SHATT AL ARAB SUBSTATION
BASRAH, IRAQ

SIGIR PA-05-009
MARCH 15, 2006

Shatt Al Arab Substation in Basrah, Iraq

Site Photo 2: 11 kV switchgear

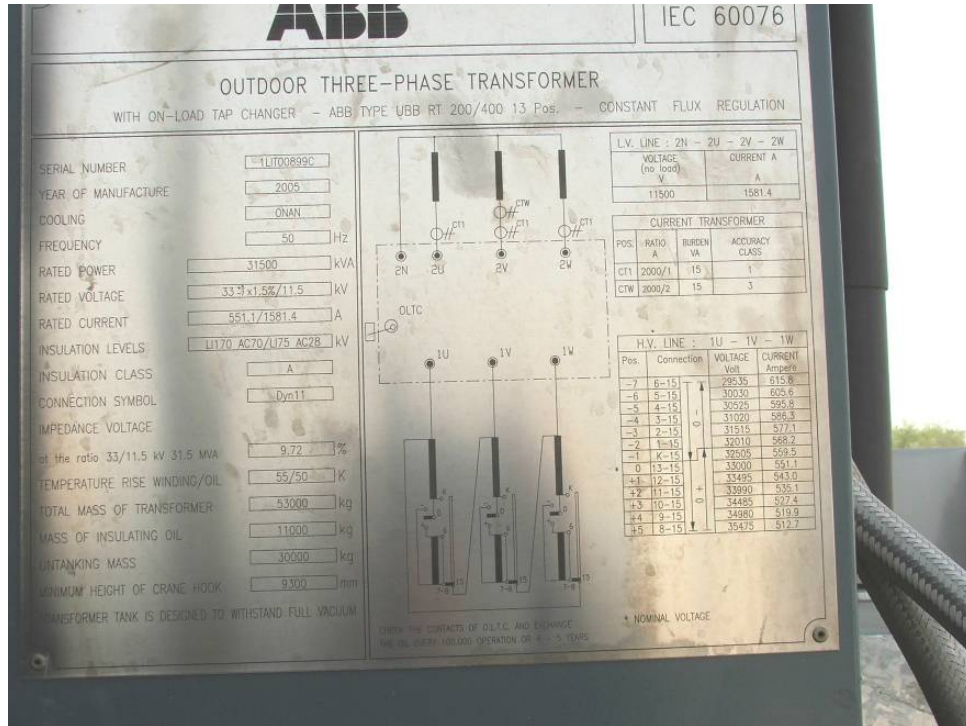
The on-site assessment verified the installation of the 11 kV switchgear. Details from the associated factory nameplate were not obtained during the site assessment; however, the equipment and installation appeared to be consistent with the contract, design, and specifications. Site photo 2 shows the 11 kV switchgear located inside the substation building.

Site Photo 4: Factory nameplate of on-load TAP changer

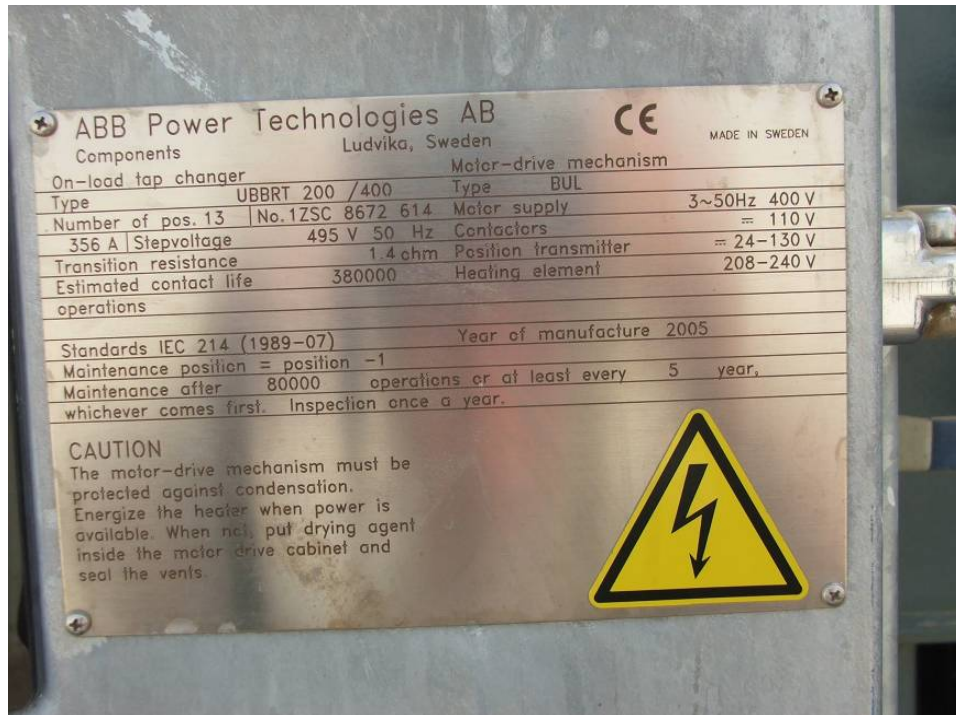
The equipment and installation appeared to be consistent with the contract, design, and specifications. Site photo 3 shows the factory nameplate of one of the two 33 kV to 11 kV transformers. Site photo 4 shows the factory nameplate of one of the two on-load TAP changers.

Site Photo 5: 11 kV to 0.4 kV transformer

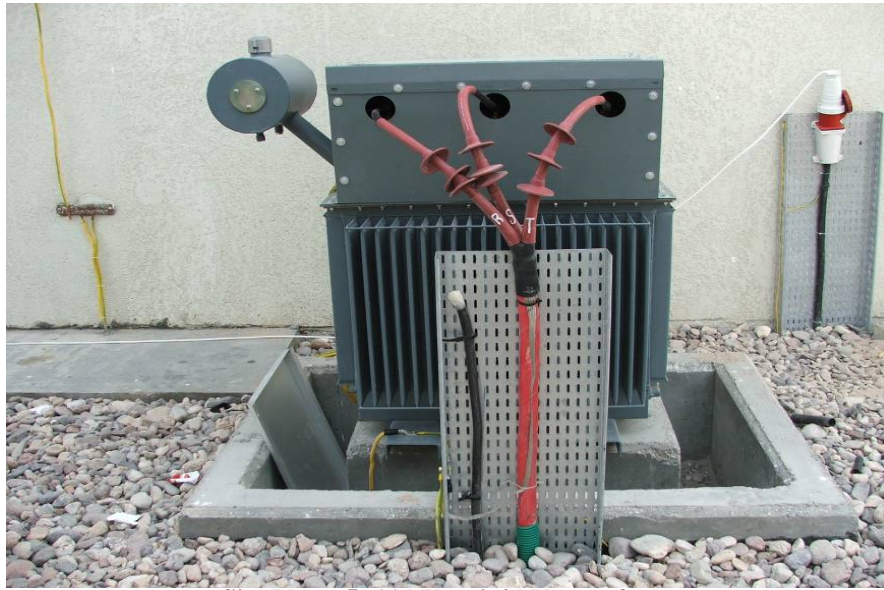
Site photo 5 shows one of the two installed 11 kV to 0.4 kV auxiliary transformers. Site photo 6 shows the associated factory nameplate. The equipment and installation appeared to be consistent with the contract, design, and specifications.
